RE: Amendment to Building Permit #B21003622

We would like to request an amendment to our building permit #B21003622 for the property located at 1715 Archers Glen in Sykesville, MD. The purpose of the amendment is to remodel the existing deck with new decking, railings, and a new set of stairs to grade.

**AMENDMENT TO  
B210003622  
SITE PLAN  
SCALE: 1" = 50'-0"  
JUNE 15, 2022**

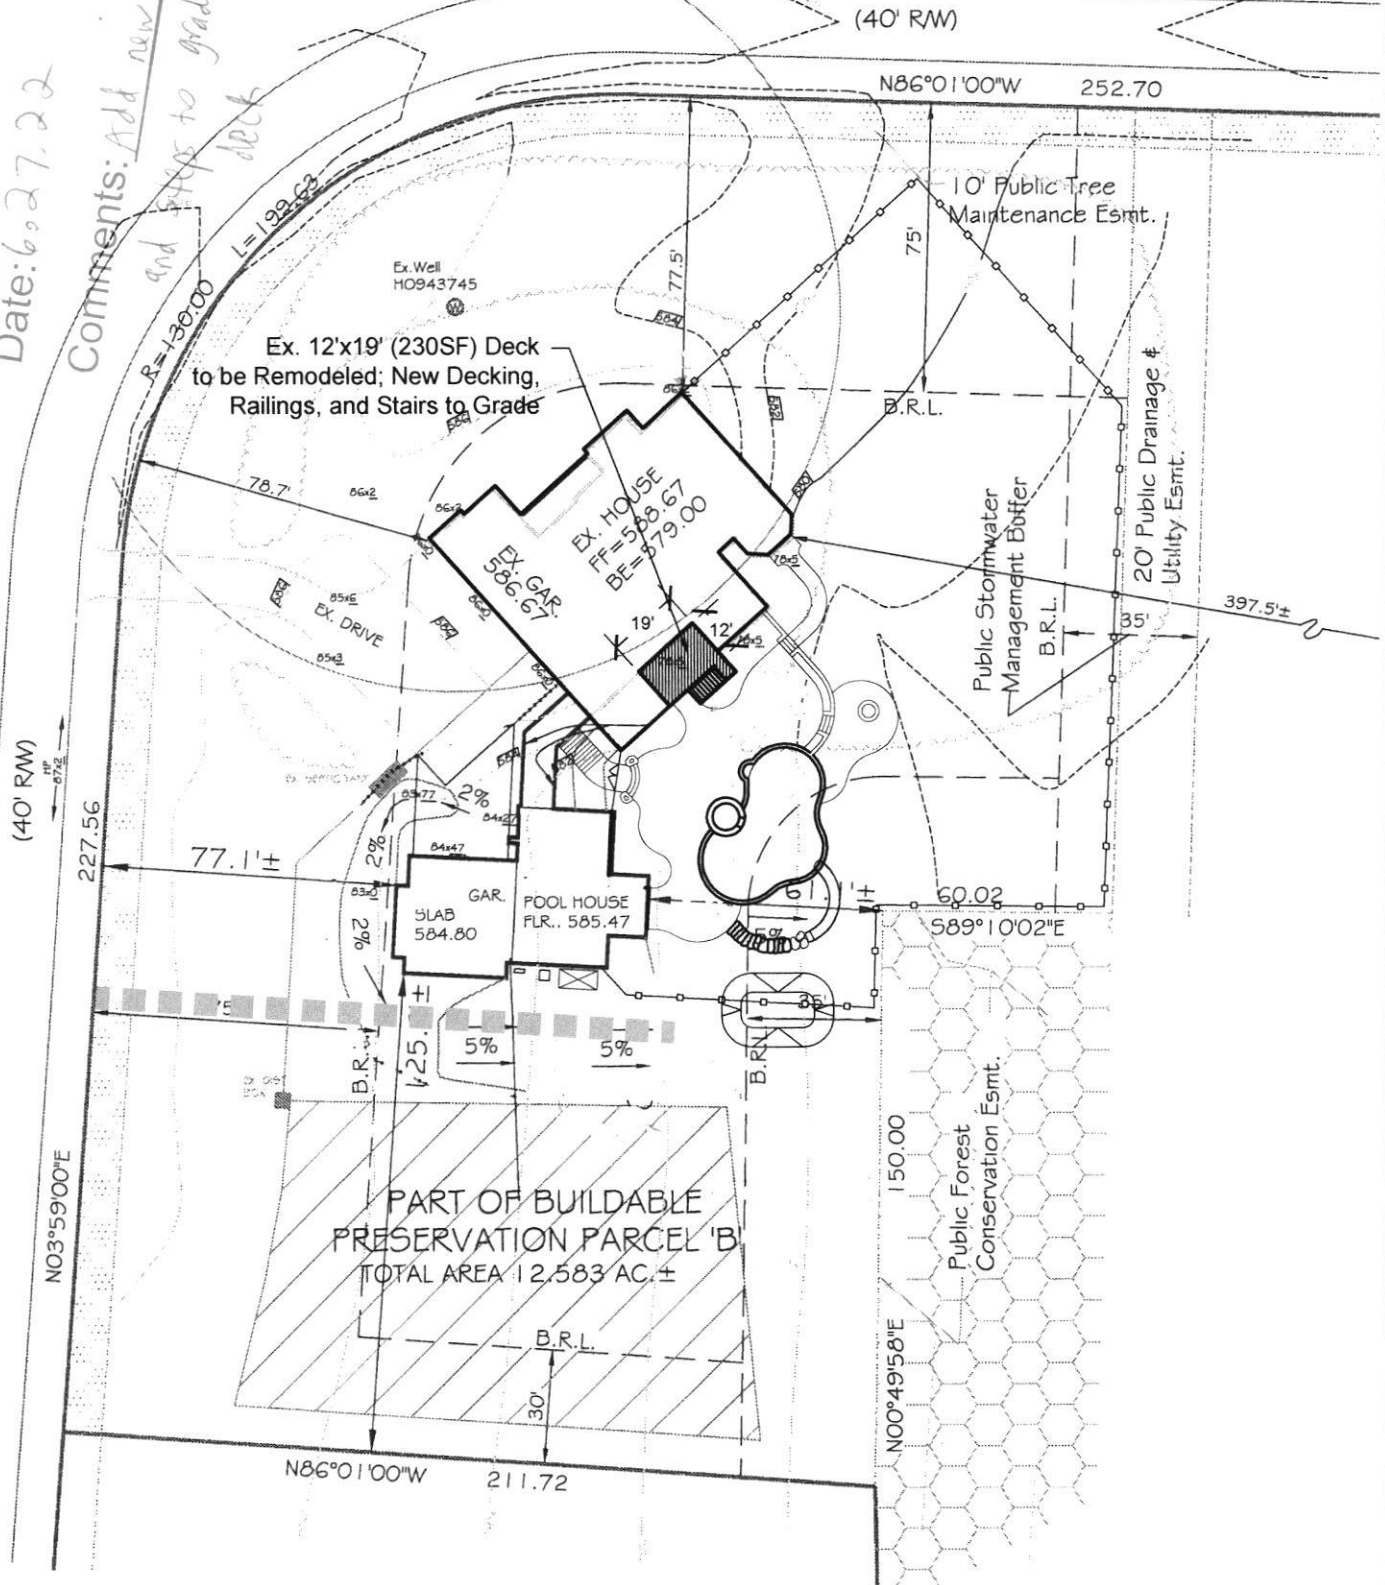
Comments: Add new decking, railings, and steps to grade on existing deck
